REVISED RESPONSE TO REQUEST FOR ADDITIONAL INFORMATION

APR1400 Design Certification

Docket No. 52-046

RAI No.: 255-8285
SRP Section: 03.08.05 – Foundations
Application Section: 03.08.05
Date of RAI Issue: 10/19/2015

Figure 1. Detailed Section in the NI basemat

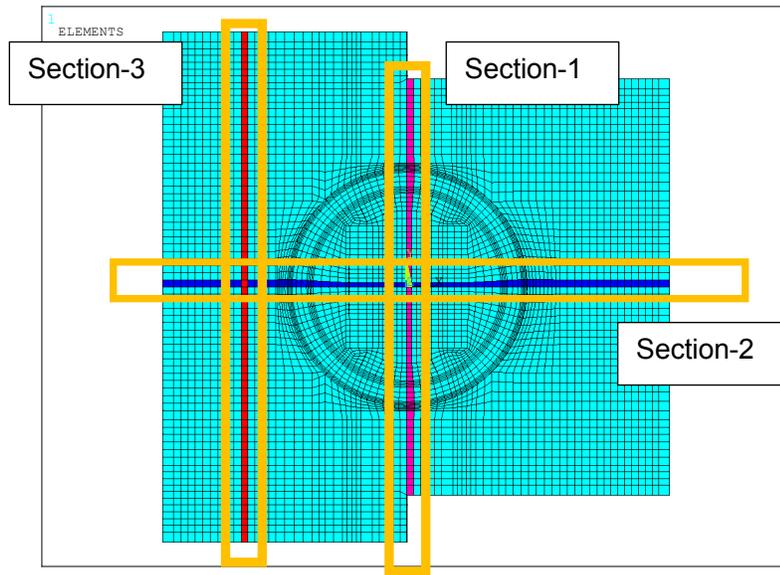
Question No. 03.08.05-7

10 CFR 50.55a and 10 CFR Part 50, Appendix A, General Design Criteria (GDC) 1, 2, 4 and 5 provide the regulatory requirements for the design of the seismic Category I structures. Standard Review Plan (SRP) Section 3.8.5.I.3, "Load and Load Combinations," states, "These should also include the loads that are induced by the construction sequence and by the differential settlements of the soil under and to the sides of the structures." Furthermore, SRP Section 3.8.5.I.4, "Design and Analysis Procedures," states, "Where a single mat foundation is used for multiple plant structures, attention is given to bending, shear, and similar factors in the basemat that are attributable to uneven settlement, construction sequence, and mat flexibility."

In DCD Tier 2, Section 3.8.6.4, "Design and Analysis Procedures," the applicant stated "The maximum differential settlement of foundation is 12.7 mm per 15.24 m (0.5 in per 50 ft) within NI common basemat. The maximum differential settlement between buildings is 12.7 mm (0.5 in) based on enveloping properties of subsurface materials." However, it is not clear to the staff how the construction sequence and differential settlement of foundations were considered in the load and load combinations. Therefore, the applicant is requested to describe how the construction sequence and differential settlement of foundations were considered in the load and load combinations. Also, DCD Section 3.8.5 should be updated accordingly.

To judge whether the soft soil case is governed for construction sequence analysis, the moment diagram for each section on profiles (S1, S8) is compared under abnormal/extreme environment load combination (LC08). Figure 1 shows the detailed sections in the basemat.
